**TECHNICAL MEMORANDA
FOR OTHER SITES
SITE INVESTIGATIONS**

2 September 1994

Prepared for
United States Army Engineer District, Kansas City
CEMRC ED-TP
601 East 12th Street
Kansas City, Missouri 64105-2896

Prepared by
Louis Berger & Associates, Inc.
295 Promenade Street
Providence, Rhode Island 02908

PHASE III SOIL SAMPLING

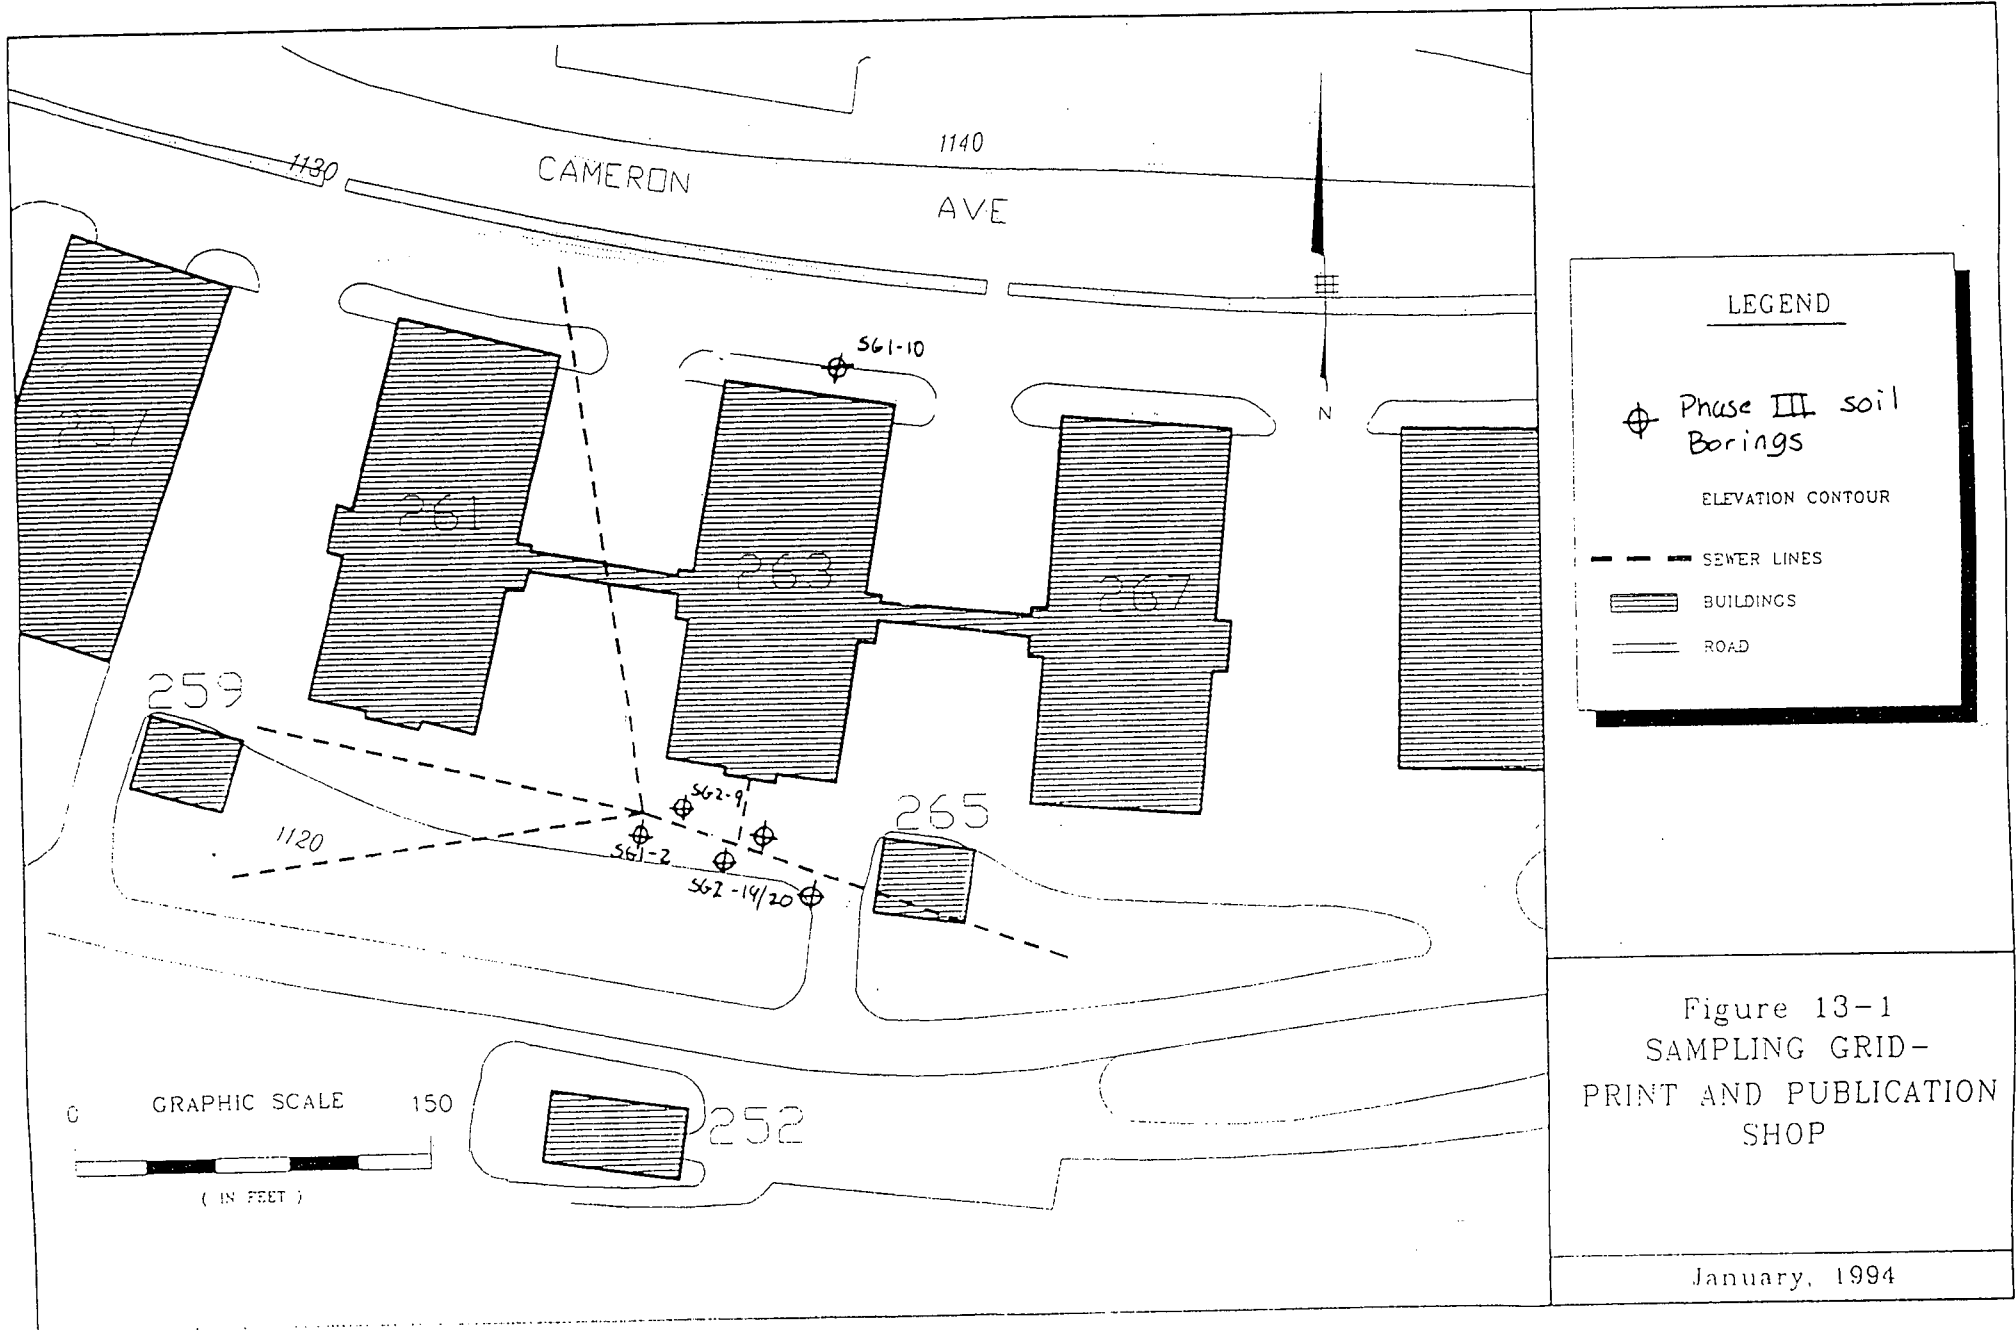
Six soil borings will be installed with soil samples collected from each boring. The locations of the soil borings and the samples will be as follows (see attached site sketch):

- One soil boring at location SG1-10 at the north end of Building 263. Samples will be collected at depths of 4 to 5, 9 to 10 and 15 to 16 feet. These samples will be analyzed for Total Petroleum Hydrocarbons using EPA Method 8015 modified and volatile organic compounds using EPA Method 8240.

- Two soil borings adjacent to and north of the sewer line: location SG2-9/10 west of the feed from the Print and Publication Shop; and a new location east of the feed from the Print and Publication Shop. Samples from each boring will be collected at depths of 4 to 5, 9 to 10 and 14 to 15 feet and from the materials directly overlying bedrock. Each of the samples will be analyzed for volatile organic compounds using EPA Method 8240.

- Three soil borings adjacent to and south of the sewer line: location SG1-2 at the junction of the sewer line lines off the southwest corner of the building; location SG-19/20 at the junction of the feed from the Print and Publication Shop to the sewer line; and a new location south of SG1-20. Samples from each boring will be collected at depths of 4 to 5, 9 to 10 and 14 to 15 feet and from the materials directly overlying bedrock. Each of the samples will be analyzed for volatile organic compounds using EPA Method 8240.

Proposed Deletion
of Soil Gas Sampling
Points

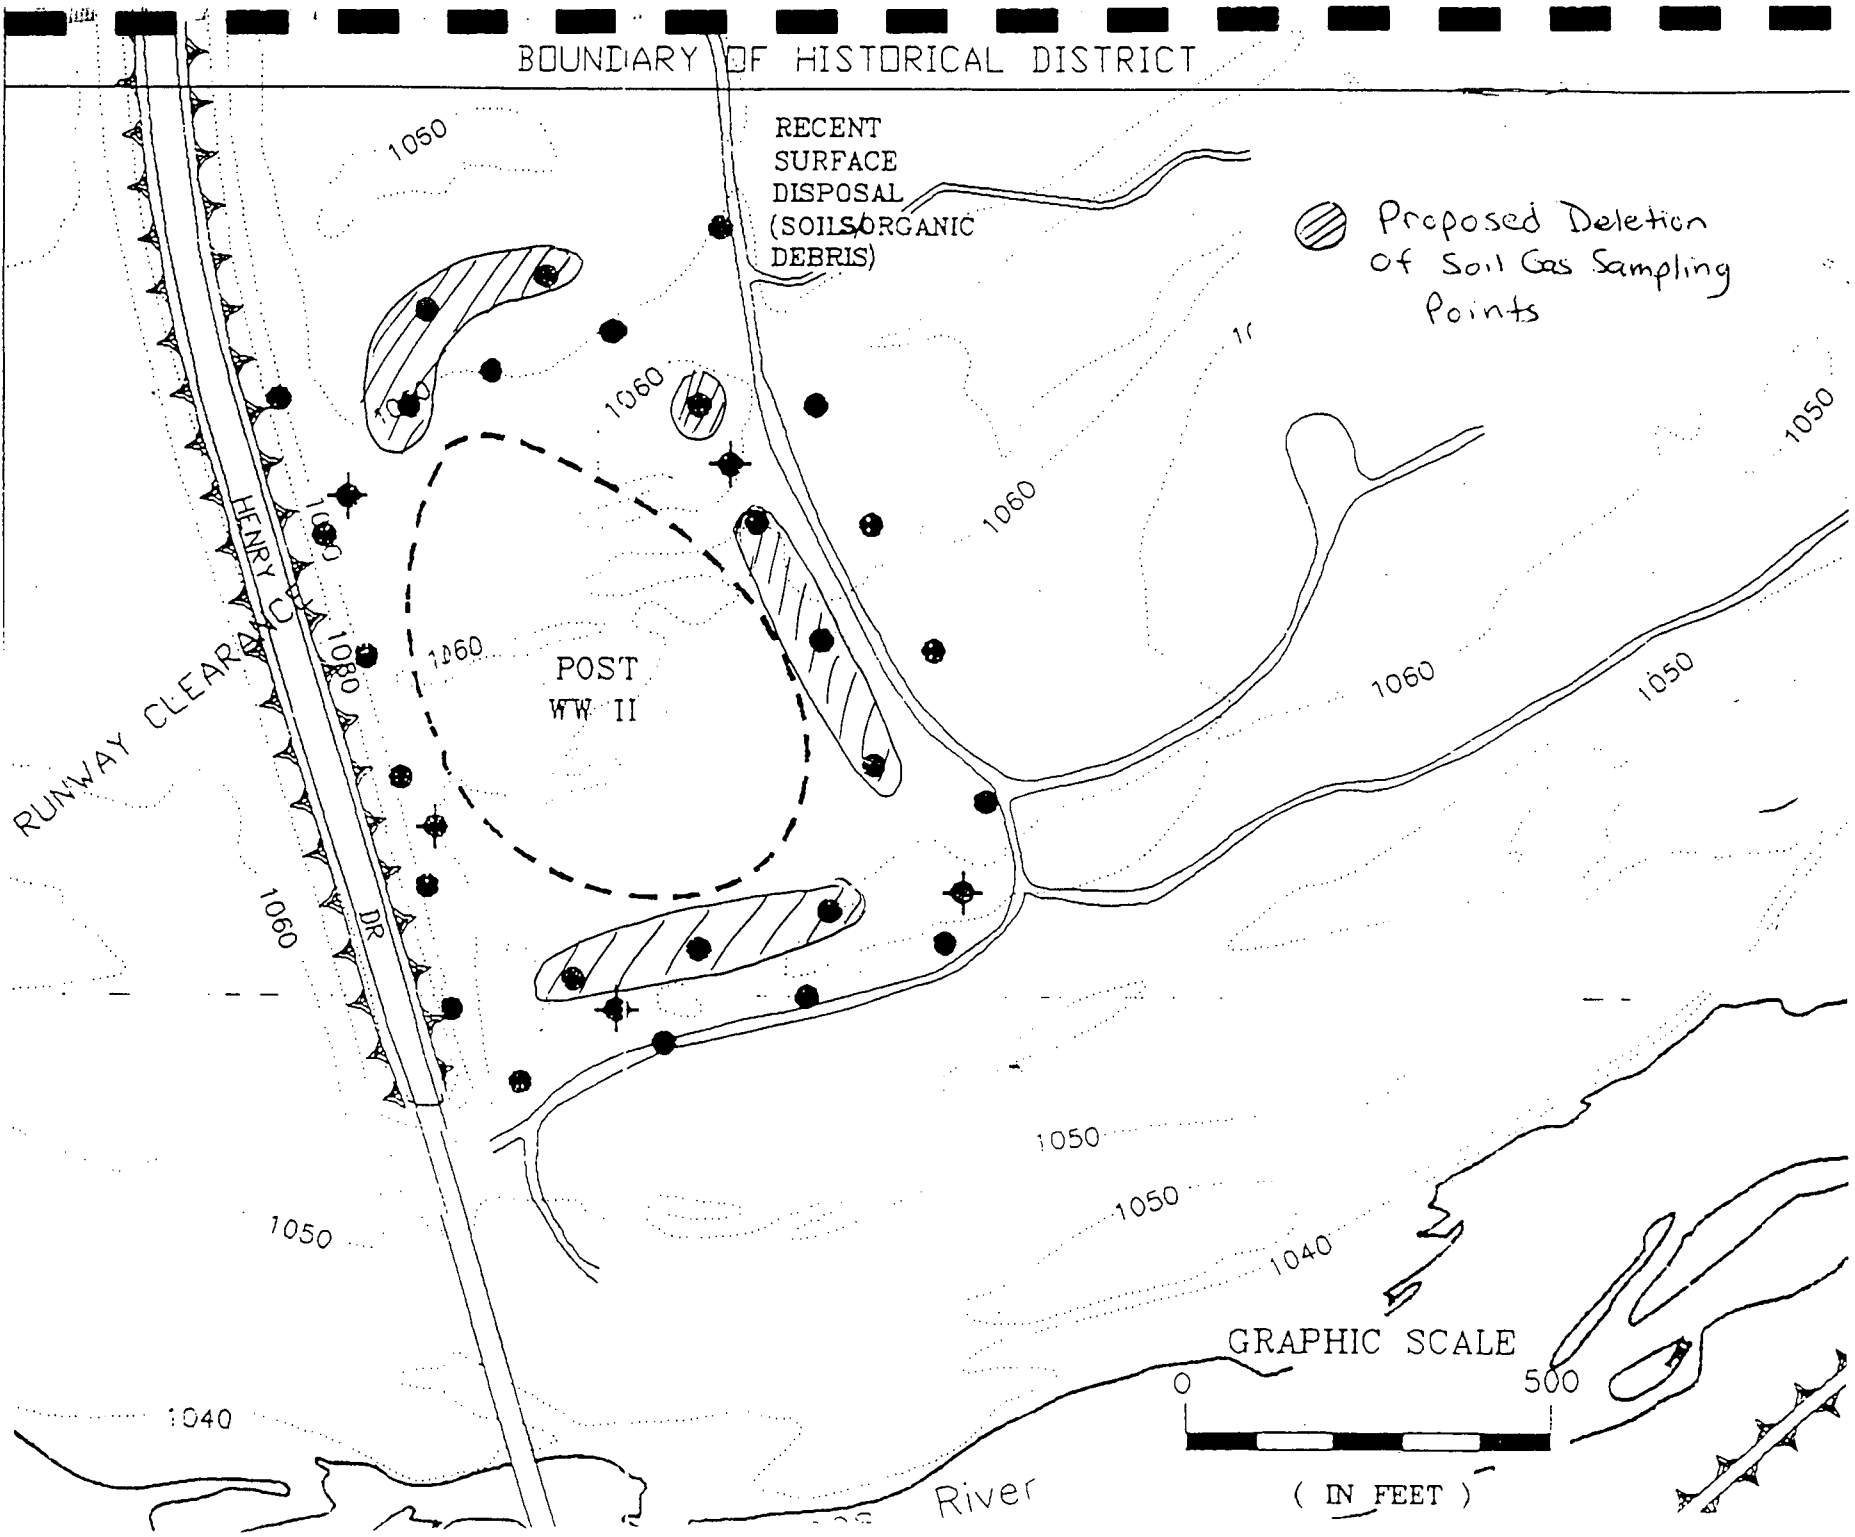
Main Post landfill. Along three sides of the landfill (north, east and south), a double row of soil gas sampling points was planned. Ten of the soil gas samples were deleted while maintaining a ring of samples around the entire area. In place of these ten soil gas sample locations, five additional groundwater screening samples were placed along the southern and eastern boundaries. These samples were analyzed on-site. [Note: the other five groundwater screening samples collected as part of Phase I were transmitted to the off-site laboratory for chemical analyses, providing adequate verification of field data.]

Figure 5-1
 SAMPLING GRID
 SOUTHEAST FUNSTON
 LANDFILL AND FORMER
 INCINERATOR
 January, 1994

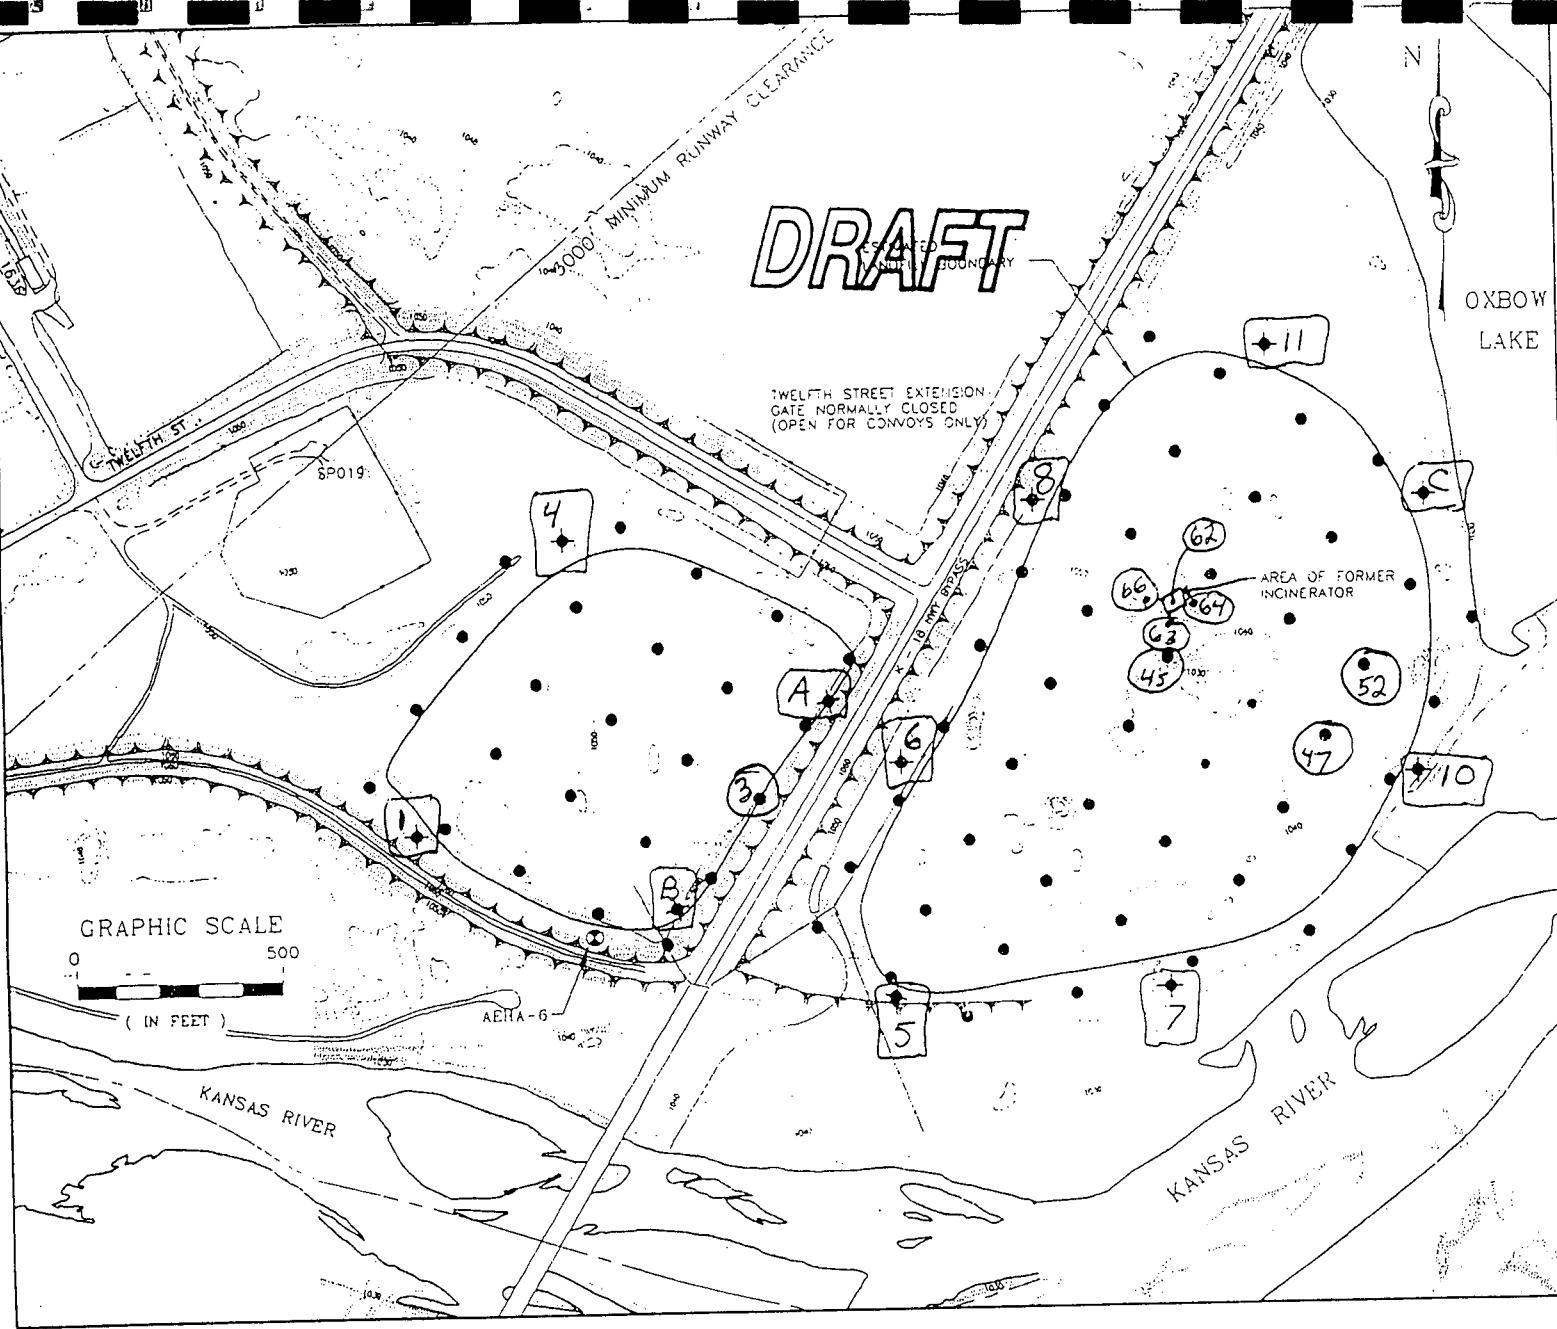
Three groundwater monitoring wells are to be installed at Southeast Funston Landfill. The recommended locations of these wells are as follows: at locations SEFLGS1-7, SEFLGS1-10 and SEFLGS1-11. Confirmation of the locations will be based upon the delineated landfill boundaries, as determined by the EM survey. If the EM survey provides a clear demarcation of the landfill boundary, the wells will be placed outside the landfill boundary, if possible. Otherwise, the wells will be placed as close to the river as possible. Existing Well AEHA 6 will be used as a background. However, before any wells are installed, access for equipment needs to be determined due to brush. UXO clearance is also necessary. The locations are identified on the attached site sketch. The samples taken from the wells will be analyzed for Volatile Organic Compounds and Priority Pollutant Metals.

SAMPLING GRID—
FORMER MAIN POST LANDFILL

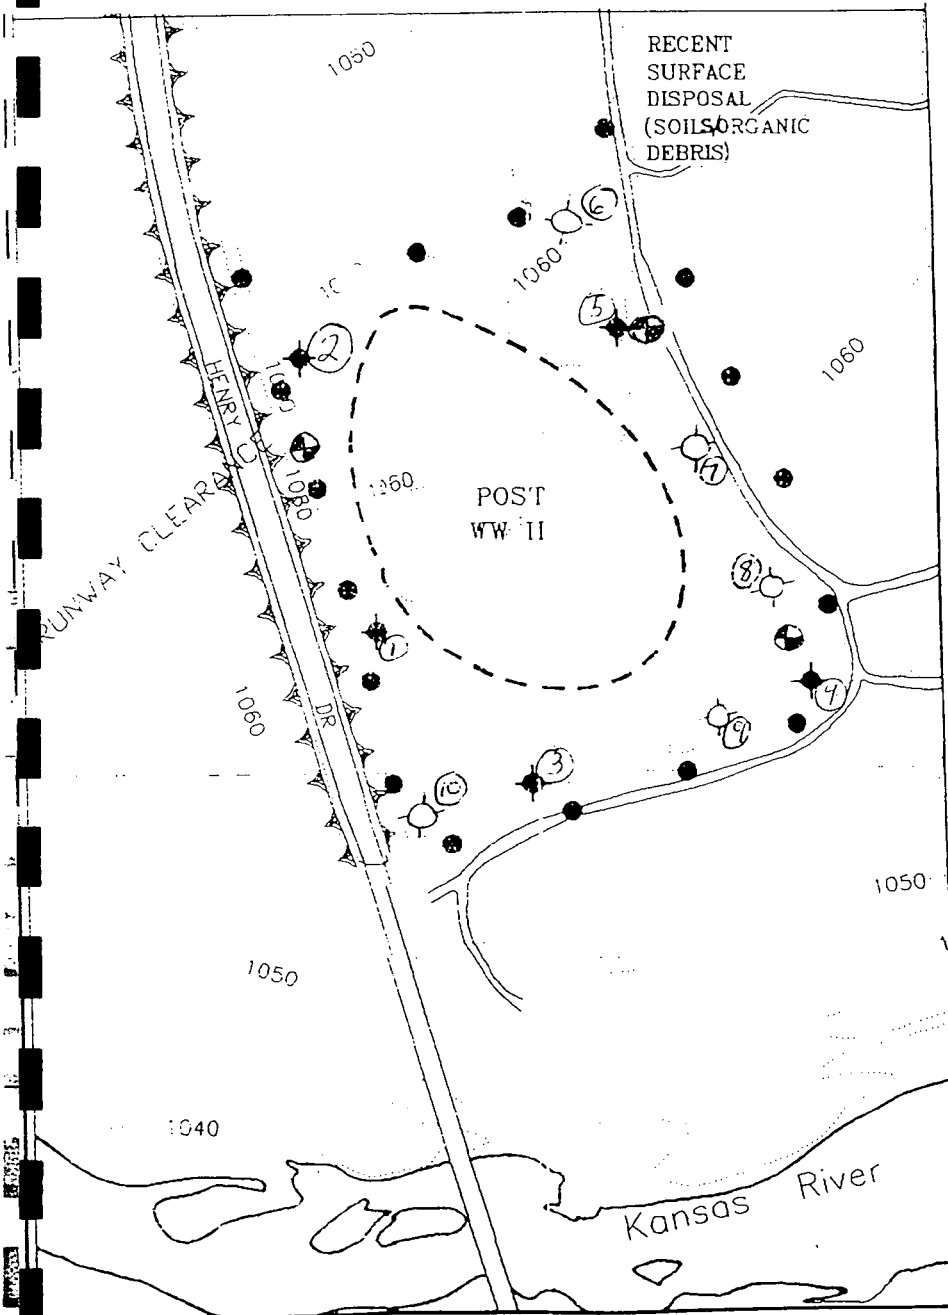
Three groundwater monitoring wells are to be installed at Main Post Landfill. The recommended locations of these wells are as follows: at location MPLGS1-5, off the southeast corner of the landfill, and to the northwest as background. Confirmation of the locations will be based upon the delineated landfill boundaries, as determined by the EM survey. The wells will be placed outside the boundaries of the landfill. However, before any wells are installed, UXO clearance may be necessary. The locations are identified on the attached site sketch. The samples taken from the wells will be analyzed for Volatile Organic Compounds and Priority Pollutant Metals.
